D117-762-011
Job Sheet 197899

Part Name: Skidtube with Standard Wearplates Fits LH or RH

DART SERVICE INSTRUCTION

TO AMEND INSTALLATION INSTRUCTIONS IIN-D117-762 REV. E AND
INSTRUCTIONS FOR CONTINUED AIRWORTHINESS ICA-D117-762 REV. 4

FIGURE 1 - GHL UPGRADE INSTALLATION

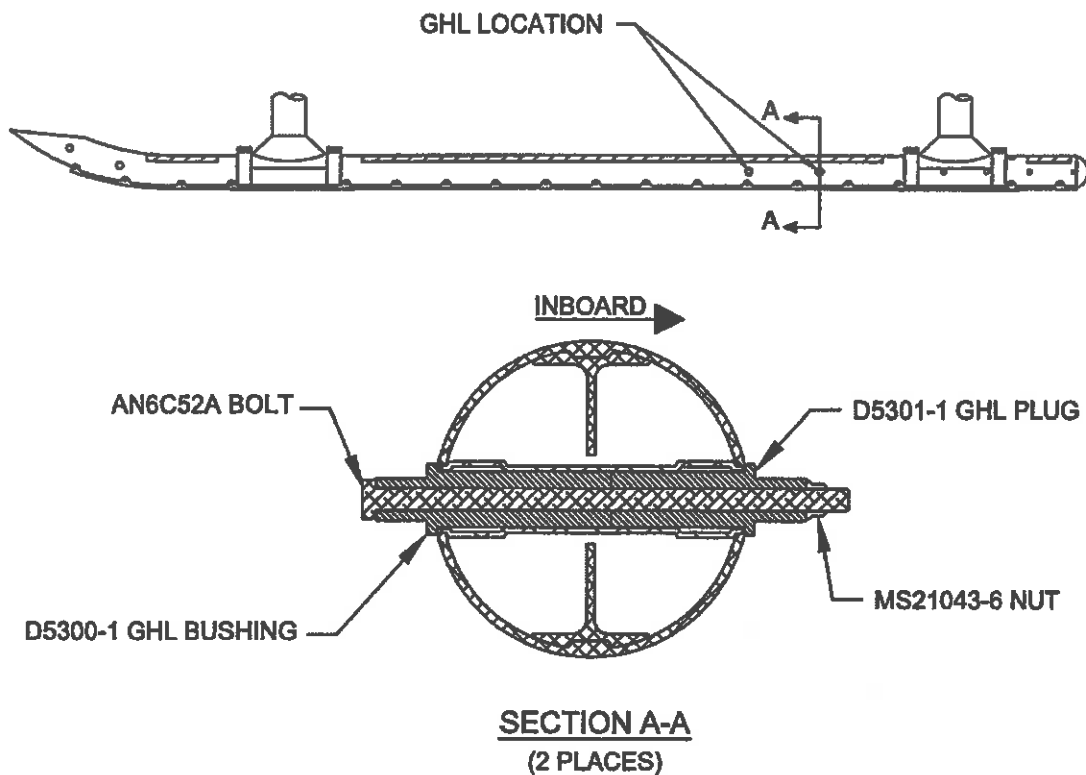
The purpose of this Dart Service Instruction (DSI) is to replace the ground handling lugs (D3864-1 Bushings, AN6C51A Bolts and MS21043-6 Nuts) on the D117-762-XXX Skid tubes with a structurally superior lug design (D5300-1 Bushings, D5301-1 Plugs, AN6C52A Bolts, MS21043-6 Nuts) as shown in Figure 1. The new hardware will be included in D117-762-011 @ CHG 004 and subsequent.

- 2.1 Loosely install (qty 2) D5300-1 GHL Bushing & (qty 2) D5301-1 GHL Plug wet with Proseal 890 or MIL-S-8802 Class B2 Sealant in location shown in Figure 1.
- 2.2 Install (qty 2) AN6C52A Bolts and (qty 2) MS21043-6 Nuts in accordance with Figure 1. Clean up squeezed out Proseal and apply fillet seal around D5300-1 & D5301-1.
- 2.3 Torque AN6C52A Bolts 160 - 190 in-lbs (18.1 - 21.5 N-m).

IS

ITEM	QTY -011	PART NUMBER	DESCRIPTION
	X	D117-762-011	SKIDTUBE INSTALLATION
50	2	AN6C52A	BOLT
51A	2	D5300-1	GHL BUSHING
51B	2	D5301-1	GHL PLUG
52	2	MS21043-6	NUT

WAS

ITEM	QTY -011	PART NUMBER	DESCRIPTION
	X	D117-762-011	SKIDTUBE INSTALLATION
50	2	AN6C51A	BOLT
51	4	D3864-1	BUSHING
52	2	MS21043-6	NUT
